RFI Response Letter

Apollo Place Data Centre (SSD-67407231)
1 Apollo Place and 1 Sirius Road, Lane Cove West

**RE: APOLLO PLACE DATA CENTRE (SSD-67407231)
REQUEST FOR ADDITIONAL INFORMATION**

Figure 8. VP 16 Year 15 - updated scheme (Source: Geoscapes, 2025)

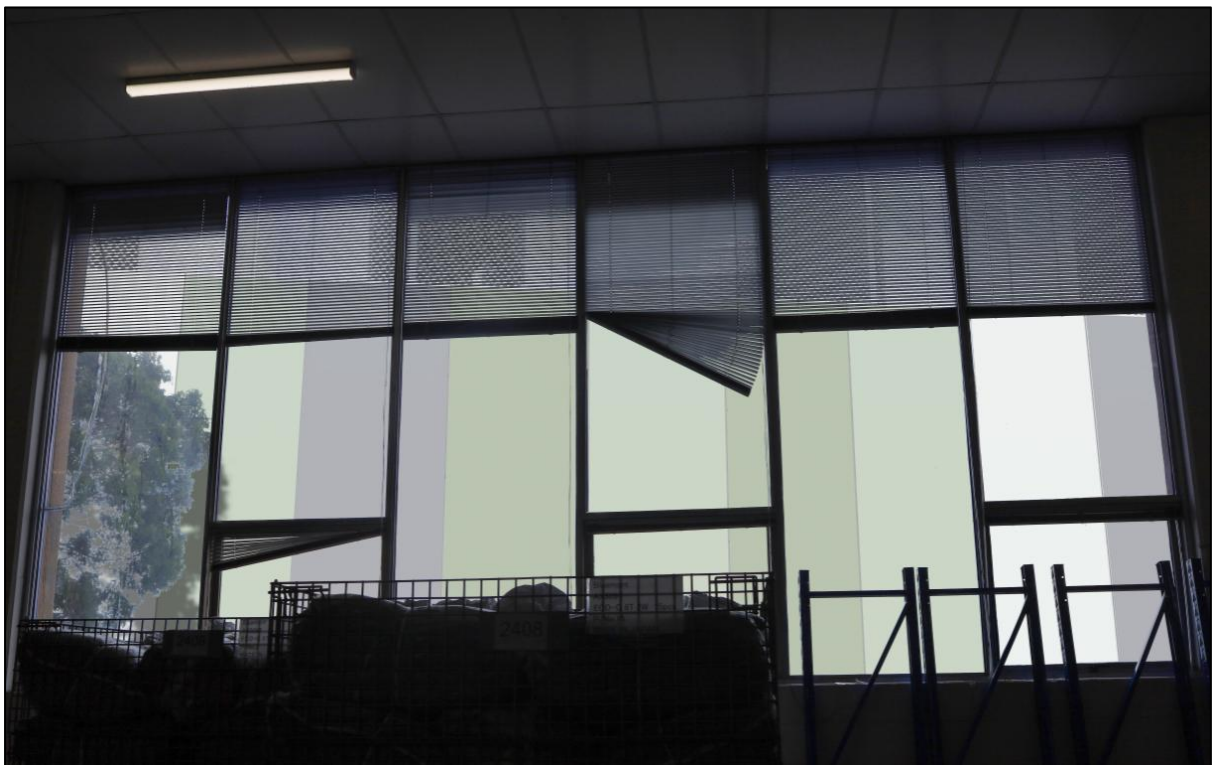
c) <i>demonstrate the proposal provides for a scale of development that when viewed from the streetscape and surrounding properties is not unreasonably dominant in terms of bulk, scale or interface with the streetscape.</i>	43	In respect of visual impact, the views from adjoining industrial and commercial development in the vicinity of the Site have been considered in the updated VIA provided at RFI Appendix 5 illustrate that façade material changes have been made to reduce the impact of the Proposal and provide an improve outlook from those spaces. Amended Architectural Plans have been provided at RFI Appendix 3 which illustrate that the material expression of the south-west façade of the Proposal has been revised with horizontal colour gradation (darker base to lighter top) to reduce visual bulk and highlights the landscape frontage along Apollo Place. In addition, express precast joints add modularity of the precast panels, adding rhythm and visual interest and reducing the building's perceived mass and visual bulk. The visual impact of the Proposal when viewed from the adjoining industrial and commercial premises on Apollo Place and Sirius Road has been significantly improved with the new material expression, addition of express precast joints, and additional planting in the front setback. As evident when comparing the original VIA and the Updated VIA at RFI Appendix 5, the Proposal is recessed into the surrounding landscape. Figure 1 to Figure 8 below show comparisons at Viewpoints VP13, VP14, VP15 and VP16 at the Year 15 scenarios from the original scheme to the updated scheme. In respect of interface with the streetscape, the maximum variation to the development standard of 32.68m is located away from Apollo Place to the north of the Site due to the natural topography of the Site. The Site falls significantly from south to north and given the nature of the use it is not practicable to step the building to follow that fall. Notwithstanding, this part of the Site is not readily visible from any road frontage of the Site and does not contribute to the streetscape presentation of the building. The maximum building height at the Apollo Place frontage varies from 19.42m to 21.49m and is minor in nature.

The west-facing windows at the rear of the upper level of No. 9 as shown in VP 16 of the VIA are highlight windows that serve an existing warehouse/storage premises. The windows have a sill height of at least 1.8m.

It is further noted that the windows have a 12.4m western boundary setback and the Proposal has a 2.4m eastern boundary setback, providing a building separation of 14.8m, which is sufficient to maintain natural light. It is further noted that the tenancy has south facing windows which remain unobstructed by the Proposal, ensuring multiple light sources to the warehouse/storage premises is maintained.

Figure 9. Updated Landscape Plan (Source: Geoscapes, 2025)

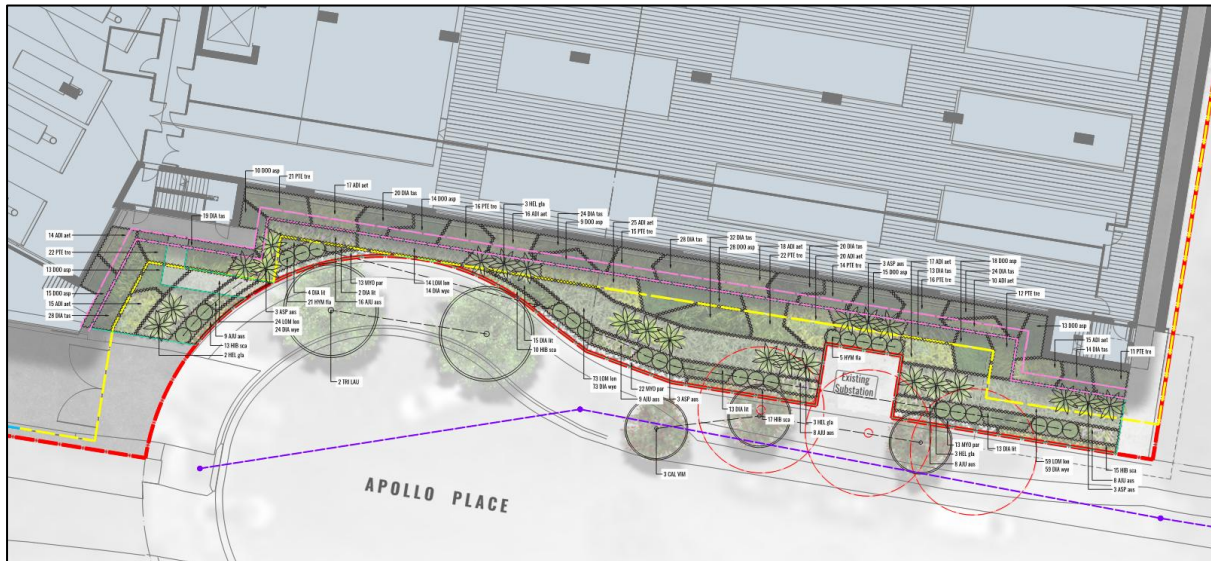
4. *The Department notes the development proposes palisade fencing along the Apollo Place frontage. This type of fencing is considered to have a detrimental visual impact on the streetscape and is inconsistent with the desired future character of the area. The frontage along Apollo Place should contribute positively to the public domain. While the Department acknowledges that security is a critical operational requirement for data centres, it recommends exploring alternative security solutions, such as internalised or integrated measures, that maintain safety while minimising visual impacts on the public realm.*

Updated Architectural Plans and Landscape Plans have been provided at **RFI Appendix 3** and **RFI Appendix 4** respectively which illustrate the palisade fencing now set back up to 5.2m from the boundary along Apollo Place and is screened by layered landscaping in front. This reduces the visual prominence of the fencing from Apollo Place and the public domain. In addition, the Proposal now includes reinstating additional 2 trees along the frontage together with the landscaping further limits its visual impact from Apollo Place. The Updated Landscape Plan is provided in **Figure 9** below
